Baker Street Two Way Project

BS2W alternative scheme proposals

Taunton Place / A41 Gloucester Place junction

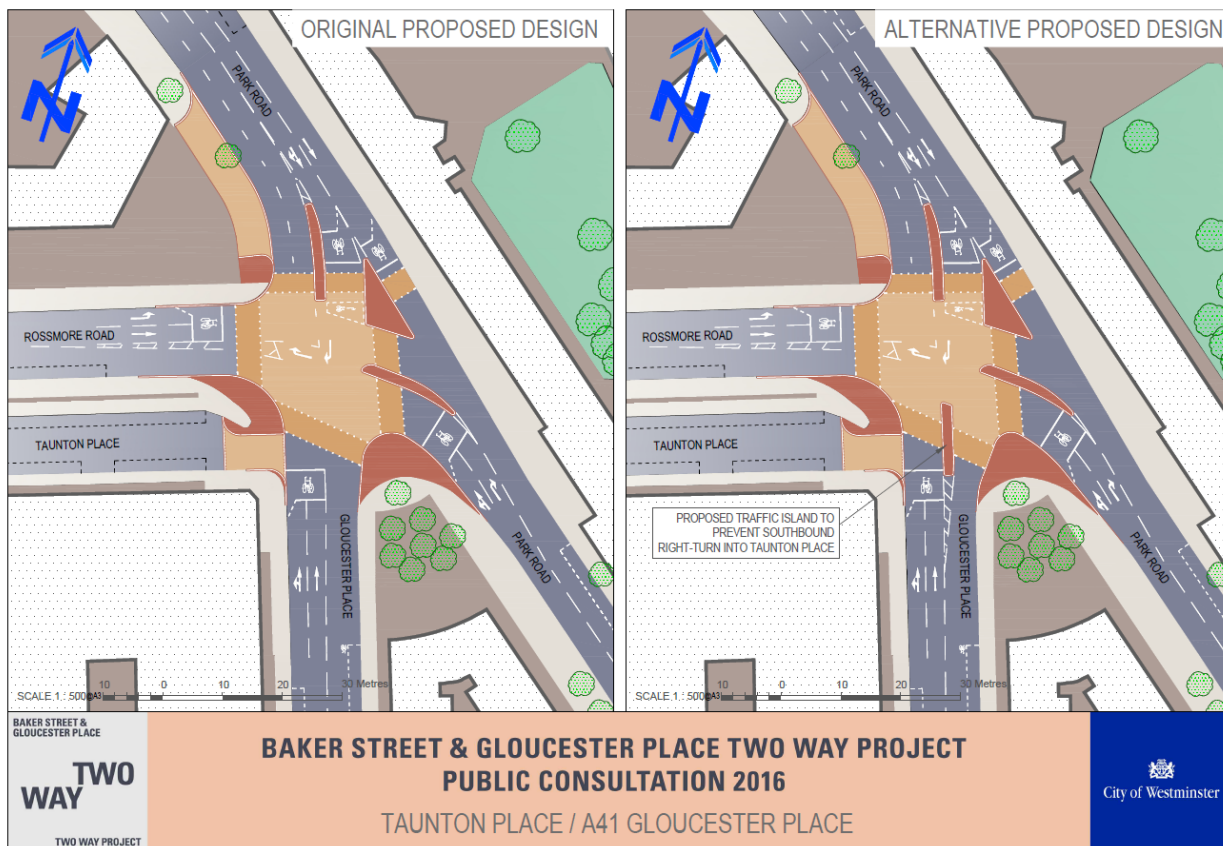
During the July 2015 consultation, concerns were raised that the original proposed design allows a right turn from Park Road into Taunton Place thereby encouraging a rat-run for through traffic towards Harewood Avenue. In the alternative design it is proposed to provide a new traffic island that will prevent this right turn.

Original proposed design		Alternative proposed design	
Benefits	Issues	Benefits	Issues
<ul style="list-style-type: none"> Provides new and convenient access to Taunton Place for local traffic from Park Road to north Marylebone area. Reduces journey distance (via Melcombe Street and Dorset Square), which reduces traffic congestion on Baker Street. Potential for associated, yet minor, air quality benefits. Increased footway area and opportunity for public realm improvements. 	<ul style="list-style-type: none"> Concern from residents that through-traffic would use Taunton Place as a rat-run through the north Marylebone area towards Harewood Avenue and Marylebone Road. 	<ul style="list-style-type: none"> Prevents right turn from Park Road into Taunton Place. Removes potential risk of rat-running. Provides pedestrian refuge within crossing over Gloucester Place. 	<ul style="list-style-type: none"> Local traffic for Taunton Place must route via Melcombe Street and Gloucester Place. Local traffic for north Marylebone area must use other proposed right turns from Gloucester Place. Longer journey increases risk of traffic congestion on Baker Street. Does not achieve potential air quality benefits.
